# UNITED STATES PATENT AND TRADEMARK OFFICE

10/807,274

| <b>Office Action Summary</b> | Application No.  | Applicant(s)      |  |

## **DETAILED ACTION**

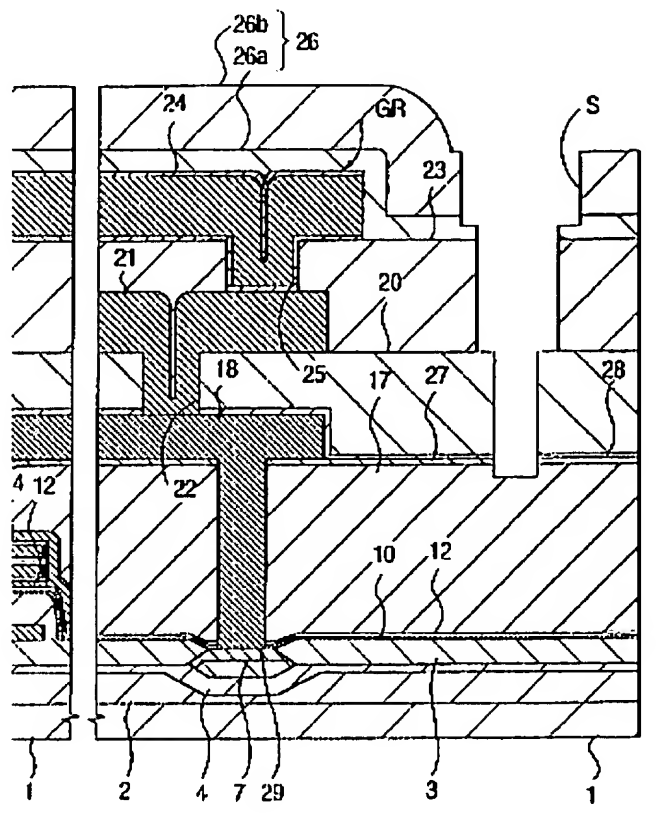
4. Claims 1, 2, 7, 9, 11, 13 and 15 are rejected under 35 U.S.C. 103(a) as being unpatentable over Suwanai et al. (US 5,994,762) in view of Wolf further in view of Kishida (US 6,770,977).

5. Regarding claims 1, 2, 13 and 15, Suwanai (e.g. fig. 11) shows a semiconductor device comprising: a semiconductor substrate 1; a first insulating film 17/27 formed above the semiconductor substrate and having a relative dielectric constant; a conductor 18 (e.g. aluminum/tungsten, col. 2/lis. 5-11) which covers a side face of the first insulating film at least near four corners of the semiconductor substrate (note that 18 is part of a guard ring GR, see fig. 3),

and a second insulating film 20 covering the outer side face of the conductor and having a relative dielectric constant of over 3.8 (inherent property of BPSG).

Suwanai does not teach that the first insulating layer has a relative dielectric constant of less than 3.8 nor a barrier layer on the at least an outer side face. Nevertheless, Wolf teaches that integrated circuits include a plurality of devices interconnected by multilevel interconnections including dielectric layers (pg 716-727). Also, the interconnect delay can be reduced by using low k dielectric material (e.g. nanoporous silica ( $\text{SiO}_2$ ) "ultra low") having a dielectric

constant of less than 2.0 (pgs. 791-795). Kishida (e.g. fig. 8b) teaches a barrier layer 202/203 composed tantalum nitride/tantalum is formed on an outer surface a conductor layer to prevent the metal atoms of the conductive layer from diffusing to the semiconductor substrate (col. 2/lis. 50-59 7 col. 8/lis. 26-28). It would have been obvious to one of ordinary skill in the art at the time the invention was made to use a low k dielectric material (e.g. nanoporous silica  $\text{SiO}_2$ ) having a dielectric constant of less than 2.0 for the first dielectric layer disclosed by Suwanai in order to reduce the interconnect delay as taught by Wolf and to include a barrier layer on an outer surface a conductor layer disclosed by Suwanai in view of Wolf to prevent the metal atoms of the conductive layer from diffusing into the semiconductor substrate.
